Debonair Limited (extension)

29th December 2020

Building Information

Discrepancies in as built drawing

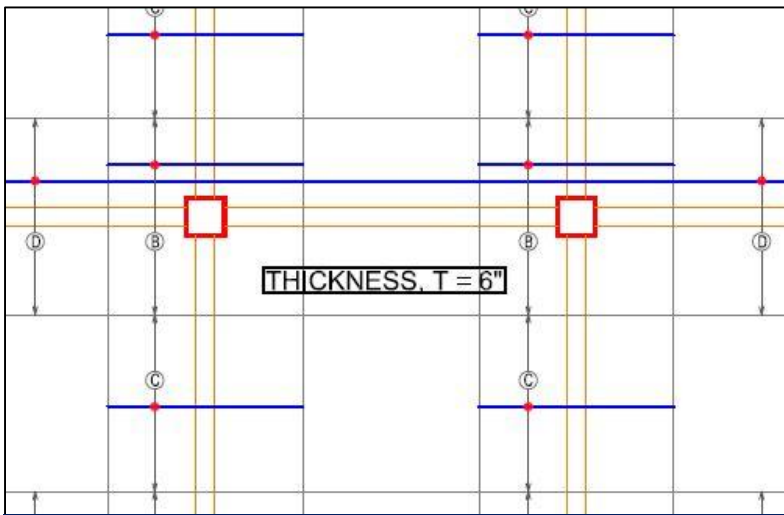
Maximum build up found 300 mm at 4th floor ablation zone.

In as-built floor layout, urinal has been shown. But during inspection, ablation zone was found at that location with 300 mm buildup.

In as-built architectural drawing, the height of the toilet partition wall has not been provided. During inspection, the height of the partition wall was found 2.5 m.

Factory engineer is required to survey the whole structure and update the as-built drawing.

In as-built structural drawing slab thickness has been shown 150mm.

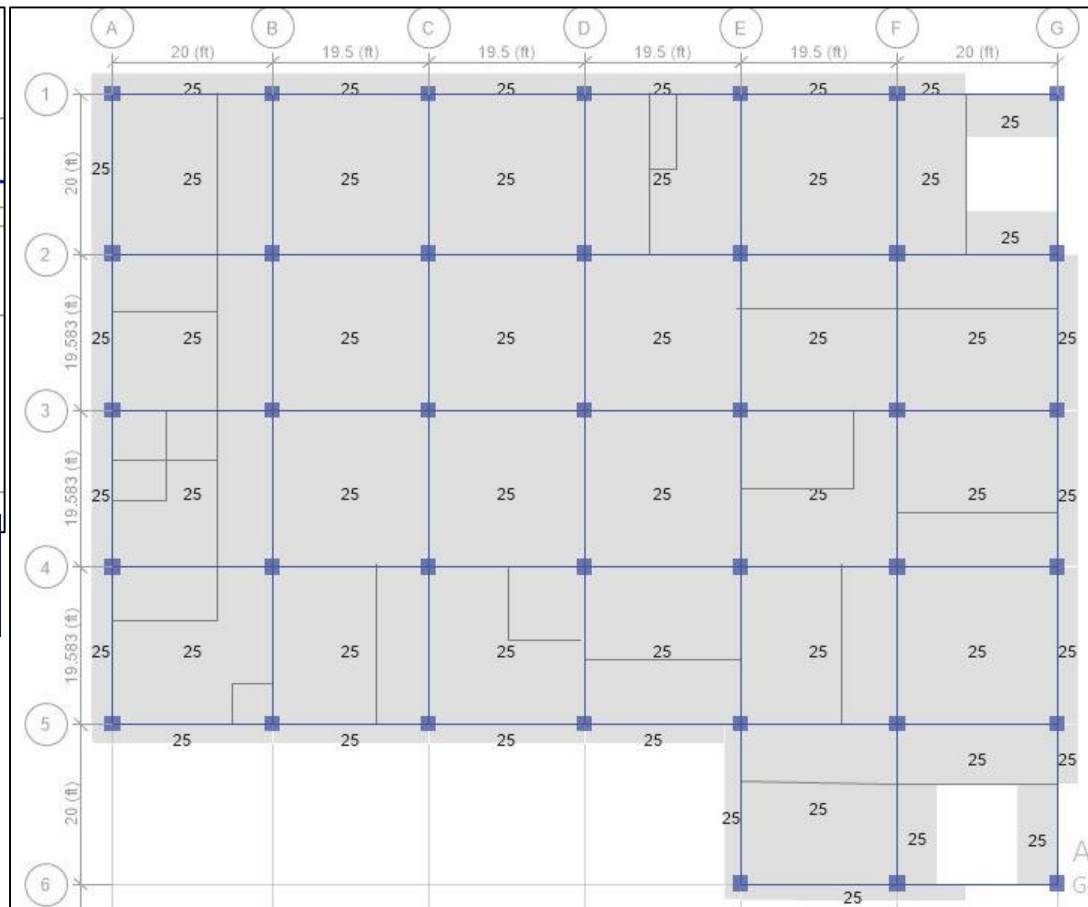
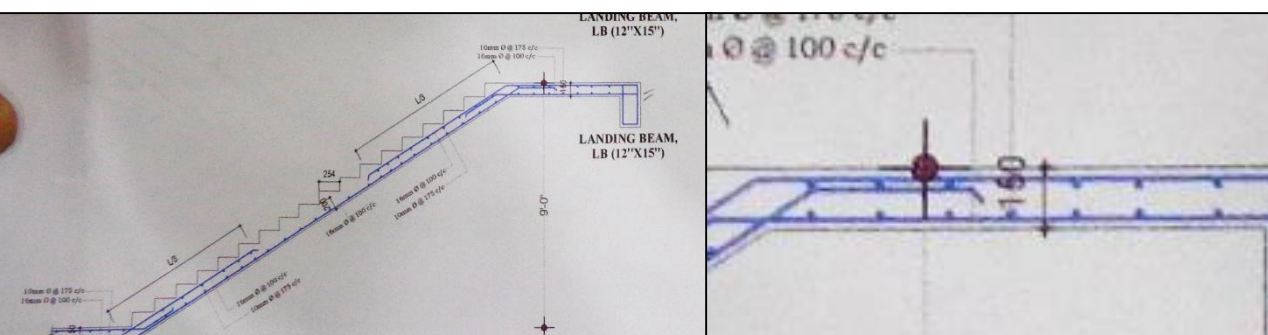
Super imposed Dead Load for Floor Finish is found 25 psf (1.2 kPa).

Thickness of the floor was found 235 mm including finishes. So, thickness of the floor finishes is 85 mm. In the software analysis, 25 psf (1.2 kPa) has been considered as super imposed dead load which is equivalent to 50 mm floor finishes. Factory engineer is required to review the design considering the additional super imposed dead load.

In as-built structural drawing landing slab thickness has been shown as 150 mm.

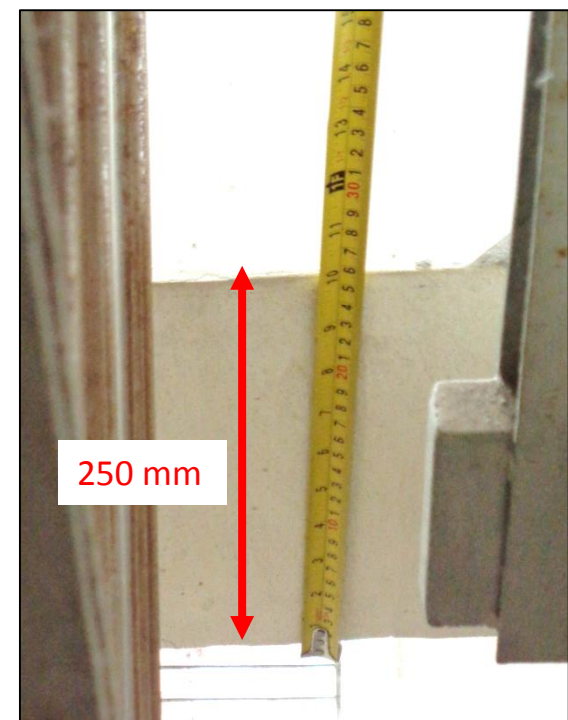
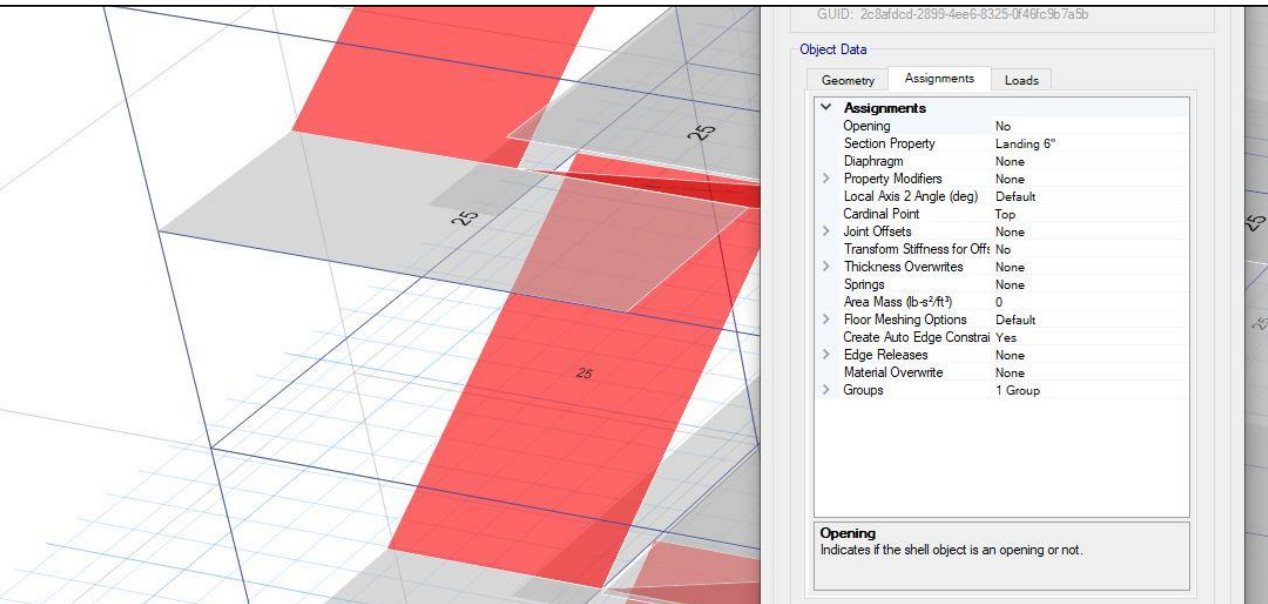
Thickness of the landing was found 250 mm including finishes. So, thickness of the floor finishes in landing is 100 mm.

Super imposed Dead Load for Floor Finish is found 25 psf (1.2 kPa).

In the software analysis, 25 psf (1.2 kPa) has been considered as super imposed dead load for floor finishes which is equivalent to 50 mm floor finishes. Factory engineer is required to review the design considering the additional super imposed dead load.

Foundation Layout plan.

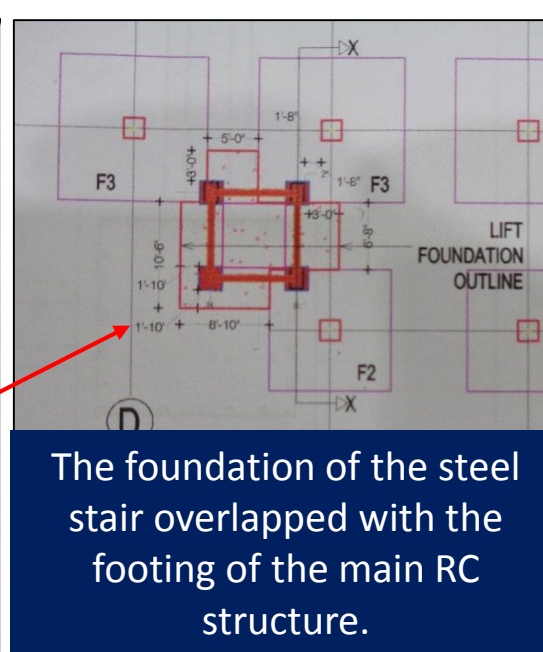
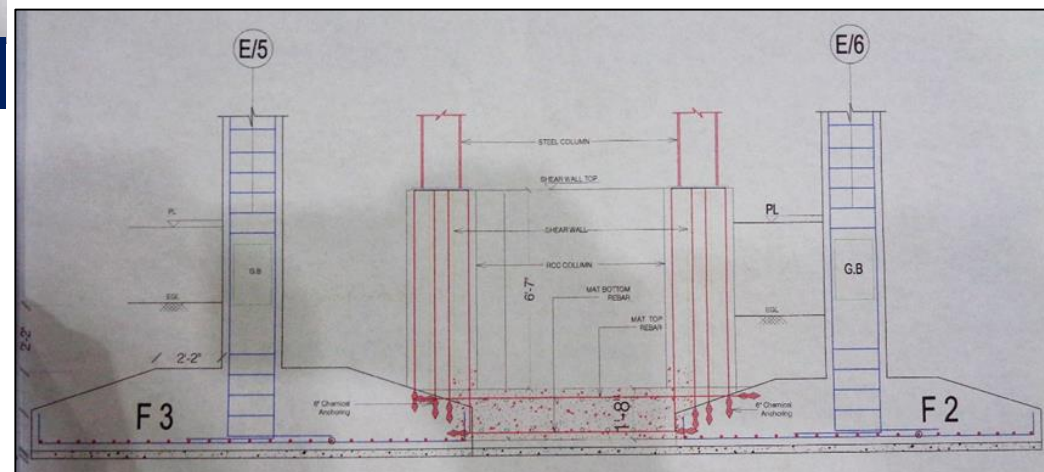
The foundation of the steel stair overlapped with the footing of the main RC structure.

As per drawing, foundation of the steel stair has been connected with the footing of the main RC structure. This issue has not been covered in design report illustrating the capacity of the new foundation system

As per BNBC every building or structure designed shall have its design documents prepared in accordance with the provision of Section 1.9.1. The design document shall include a design report, and a set of structural drawings, which shall be prepared in compliance with section 1.9.1.1 and section 1.9.1.2 as per BNBC. Factory engineer is required to revise the design documents considering the present condition of the structure.

Damage in waterproofing

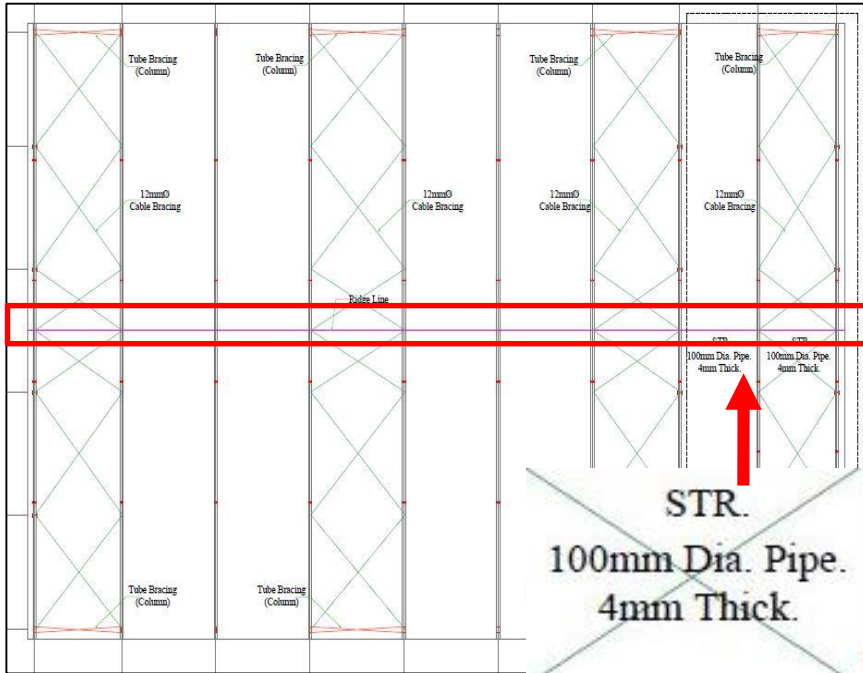
Cement-based finishes of waterproofing was found damaged in certain areas. Consequently, any cracks or damage in the surface finishes on the roof will allow water to pond and seep into the concrete slab beneath the finishes and cause long-term soaking of the slab.

Missing lateral stability element in long direction

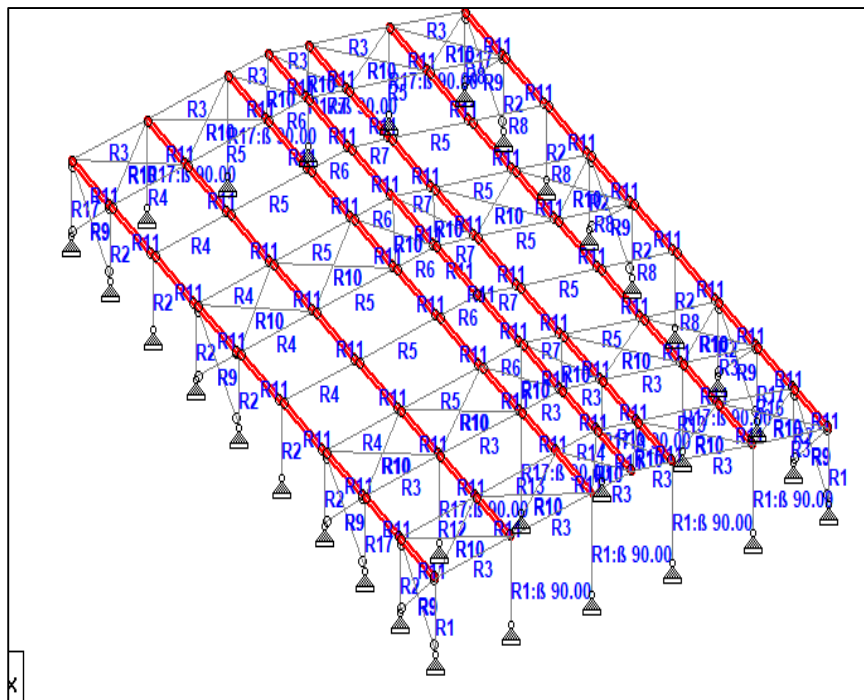
100 mm diameter pipe shown along ridge as a compression strut

No compression strut was found along ridge.

Factory engineer is required to check the lateral stability in the long direction and requirement of stability member/compression strut in that direction.
All serviceability and stability checks are required to prepare in compliance with section 1.9.1 as per BNBC.

Connection of purlin to rafter

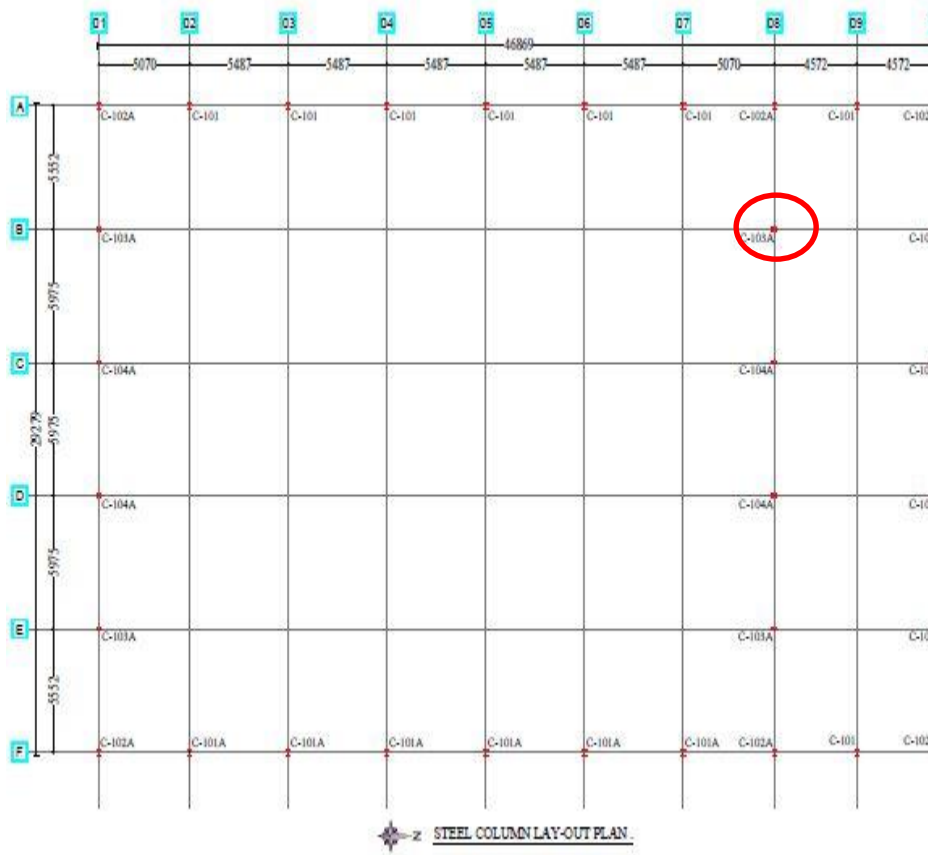
Purlins are assigned in FEA model along rafter to rafter as compression strut

Purlins are assigned as compression strut in FEA model along rafter to rafter. Factory engineer is required to verify the Design Report considering the connection of rafter to purlin and prepare full set of drawings in compliance with section 1.9.1 as per BNBC.

Capacity of steel rack to be reviewed

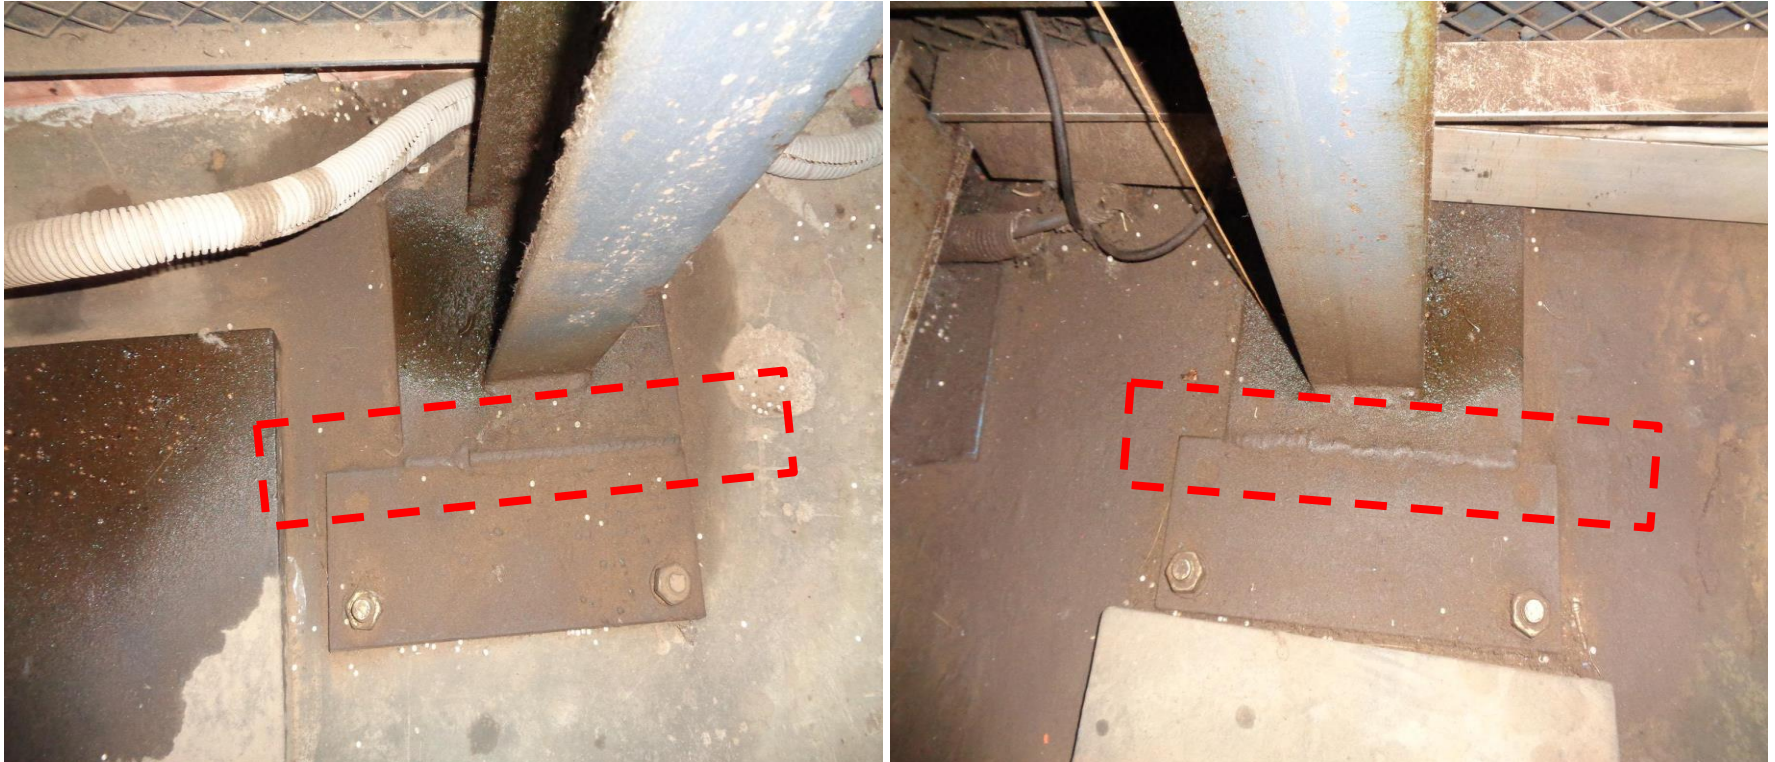
Storage was found resting on multi storied steel racks inside the Finished Goods Warehouse Shed. Storage was found maximum 2 kPa on the rack's floors. No design documents and allowable load plan were available. Factory engineer is required to produce load plan according to the capacity of steel rack.
